COMMUNITY MONITOR COMMITTEE Altamont Landfill Settlement Agreement

AGENDA

subject CMC Meeting of 10/8/14 - Agenda Item 6.4 - Review of Reports Provided by ALRRF

MEMO

Note: colors indicate well installation time frames, e.g., all wells represented in green were installed in the same construction period of several weeks.

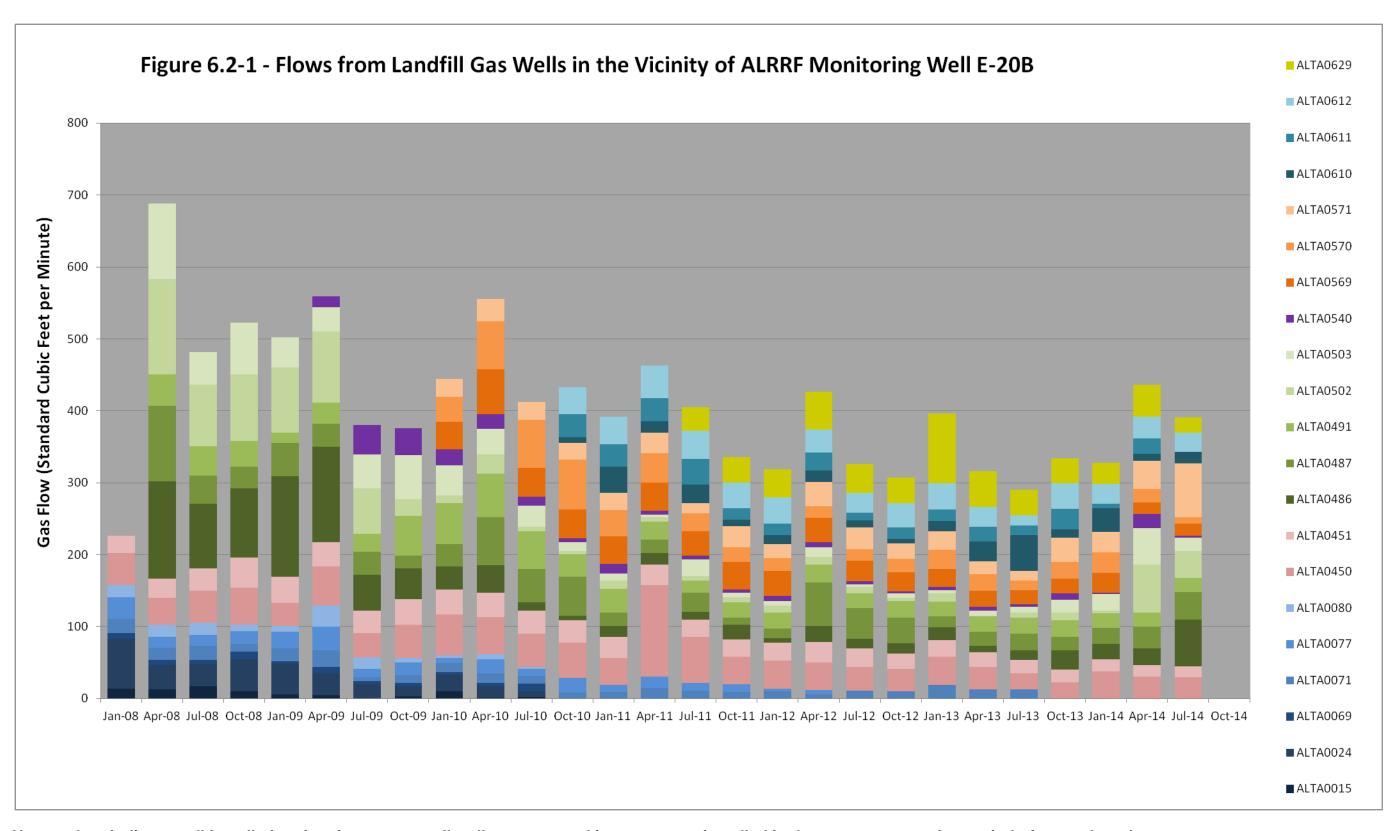
Groundwater Monitoring Well E-20B – The Water Board's November 2013 letter also expressed concern that at least one of the VOC contaminants seen at well E-20B (tetrahydrofuran) is associated with leachate rather than landfill gas, and therefore landfill gas extraction may not be a complete solution to the contamination problems indicated at that well. ALRRF responded on February 4, 2014 with an updated evaluation of the situation at that well. This response, prepared by SCS Engineers, stated that "it remains our assessment that the source of VOC's in this well is landfill gas and not leachate" and proposed continuing the current monitoring protocol.

The Water Board replied in a May 23 letter that requested a revised Corrective Action Plan to address their concerns in more detail. The letter also called for replacement of LFG wells that had been decommissioned in the vicinity of well E-20B. The ALRRF provided a response on August 13 that proposed several additional measures, including several small-scale LFG wells in close proximity to well E-20B, more detailed monitoring, and an

additional monitoring well to be installed at the first serviceable location downgradient of well E-20B. This response also included tables with landfill gas extraction data from each well in the vicinity of E-20B.

At this time we do not know if the Water Board has accepted this proposed Corrective Action Plan.

Figure 6.3-1 Monthly Volumes of Revenue-Generating Cover

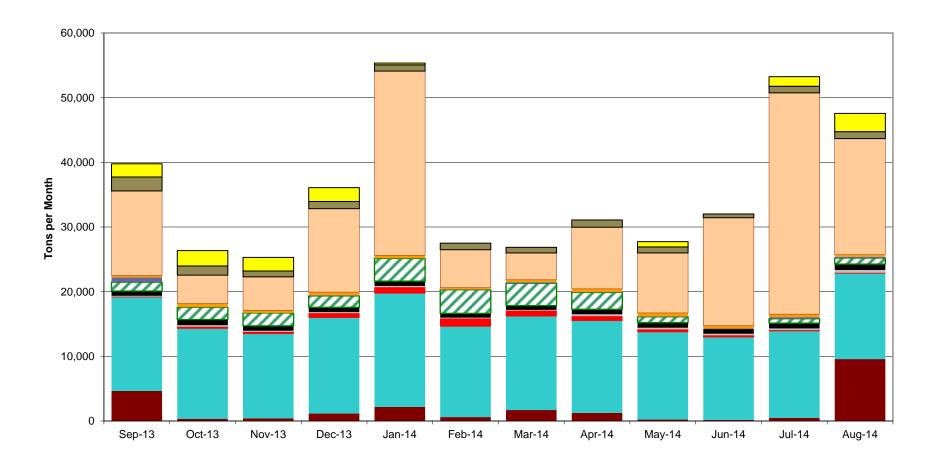
Also attached are graphs showing monthly tonnages by type of material for the most recent 12-month period, as in prior reports. Figure 6.3-1 shows the breakdown of materials that make up Revenue-Generating Cover. Figure 6.3-2 shows these same quantities, plus the municipal solid waste tonnage on the lowest (and largest) part of each bar.
